Poor Start –  
Fuel Line Knocking Noise –  
Repair Procedure

MODEL 1998 MY  
V8 XJ Series

VIN 812256-851000

ILLUSTRATION 1

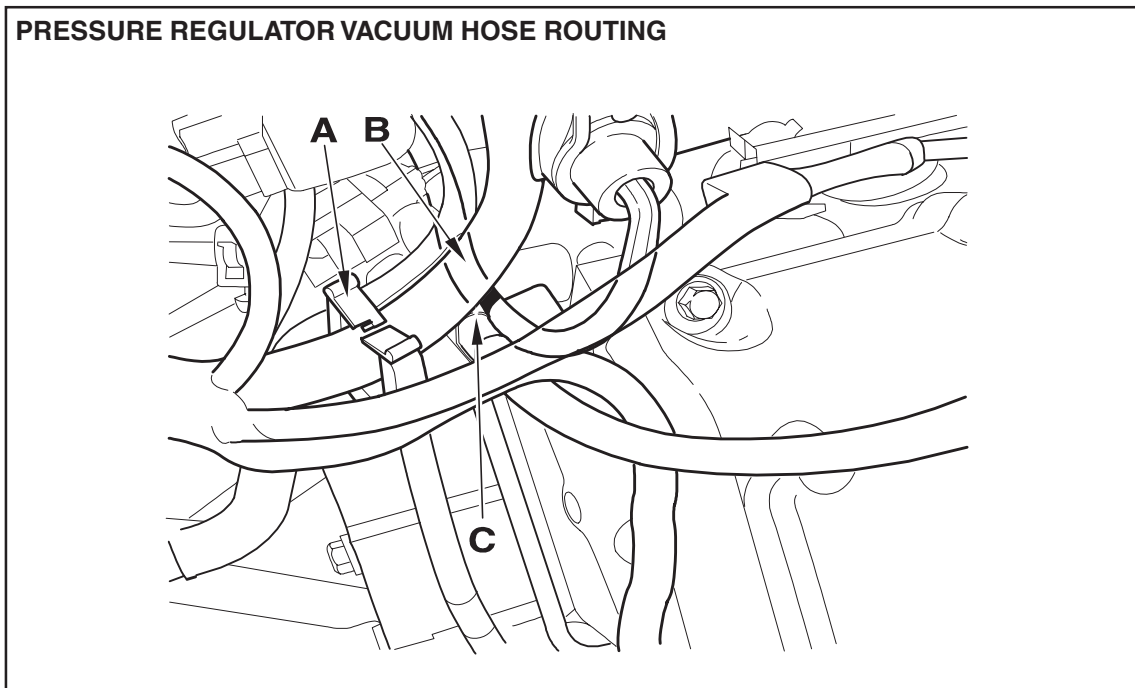
Some 1998 MY V8 XJ Series vehicles, within the above VIN range, may experience a knocking sound from the fuel line, or excessive cranking being required to restart the engine. The possible cause may be that the vacuum hose from the fuel pressure regulator to the throttle body unit is kinked or restricted due to pressure from a wiring harness.

If case of a customer complaint of fuel link knock on vehicles within the above VIN range, check for a kinked vacuum hose at the rear of 'A' cylinder bank (right side). Below and outboard of the throttle body there is a support bracket that holds clips 'A' and 'C' (Illustration 1), which locate the fuel injection and starter motor harnesses. Ensure that the vacuum hose is routed through this area in a way that it can not be kinked or restricted where it passes under the harnesses but above

Before VIN 851000, the location of harness clips 'A' and 'C' was the opposite of the layout in Illustration 1. In case this concern occurs, swap the location of these two clips to the layout for later vehicles, as shown in Illustration 1. This will provide a greater clearance between harnesses and bracket where the fuel pressure regulator hose passes between harness and bracket at 'B'.
